Subject: AP1000 Response to Request for Additional Information (SRP 6)

AP1000 TECHNICAL REPORT REVIEW

RAI Response Number: RAI-SRP6.2.2-SRSB-10
Revision: 2

RAI Response Number: RAI-SRP 6.4-SPCV-06
Revision: 1

Figure 1: Intact Loop DVI Recirculation Flow

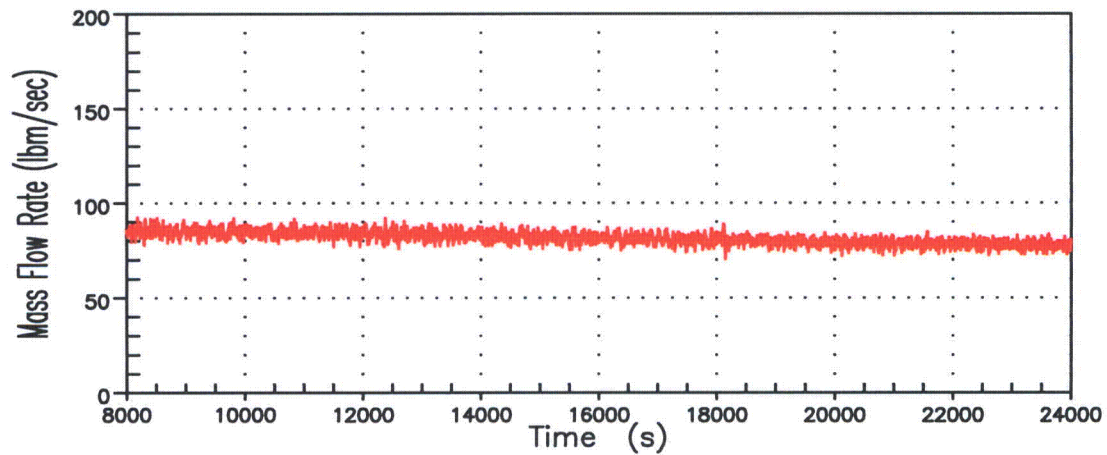
In its review of part a. to the response to RAI-SRP-6.2.2-SRSB-10, the staff asked Westinghouse to identify if the 60% bypass flow assumption was based on low water level in the containment, which would limit the recirculation flow, or was based on a high water level, which could drive a bigger percentage of unfiltered debris through the DVI break location? On review of the calculation APP-PXS-M3C-049 Rev. 0, the staff found that the 60% number was based on integrated flow through the break divided by the total integrated flow into the core region, but time periods during the transient changes this percentage significantly. Describe the variations you expect in this percentage split with respect to time. Also, using the flow percentage splits between the break and the recirculation screens is not an adequate representation of the debris split because sump recirculation screens are protected from debris by barriers such as the large protective shelves above the screens. On the other hand, there are no protective barriers for the break location and it is completely open to all suspended debris in the containment sump area. Clarify how this bias accounted for in the calculation?

The figures on the following pages show the calculation of the flow ratio for recirculation through the break. The WCOBRA/TRAC time scale is such that zero seconds on the x-axis corresponds to 2500 seconds after the initiation of the DEDVI break. Containment recirculation begins at 7000 seconds (9500 seconds after the initiation of the DEDVI break), so the time interval of most interest on the WCOBRA/TRAC plots begins at 7000 seconds. Figure 1 provides the intact DVI line flow following recirculation. Figure 2 provides the flow into the reactor vessel from the break location. Figure 3 provides the instantaneous ratio of flow into the core from the break location to total core flow (flow through break into the reactor vessel / total flow into reactor vessel) following recirculation. At all times after recirculation, the instantaneous flow through the break ratio is less than 75% of the total core flow.

Figure 3: Instantaneous Flow through Break Ratioed to Total Core Flow

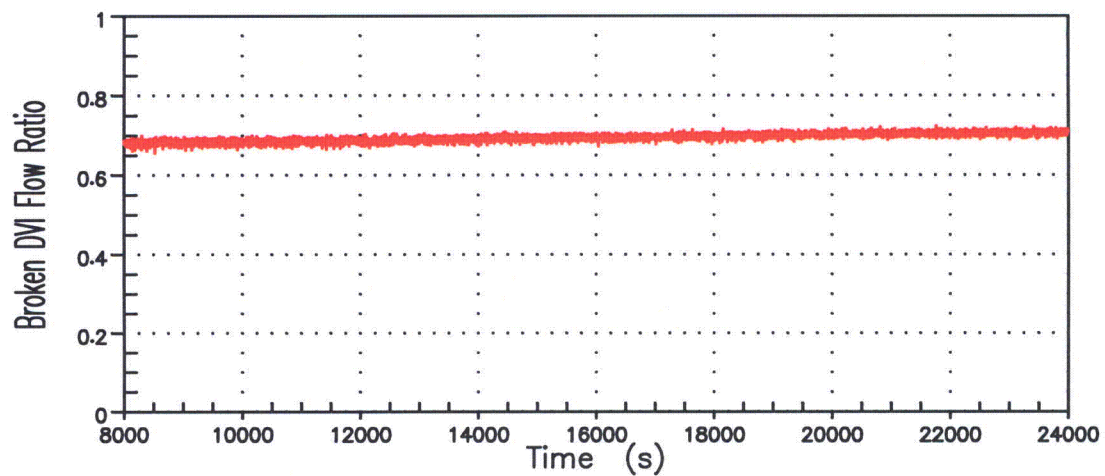
- a. Clarify, since the amount of bypass debris is significant for determining the effect on the core, the basis for the 60% number.
- b. Describe how this relates to the total residue mass in the containment of 227 kg (500 lb) that you assumed, as documented in NUREG-1793, Section 6.2.1.8.2.
- c. Clarify whether the total mass number to the core includes bypass debris from the recirculation and IRWST screens.

As shown in Figure 3, once recirculation is established, the instantaneous flow split through the break is always less than the 75% value. From Figure 4, after 17000 seconds (approximately
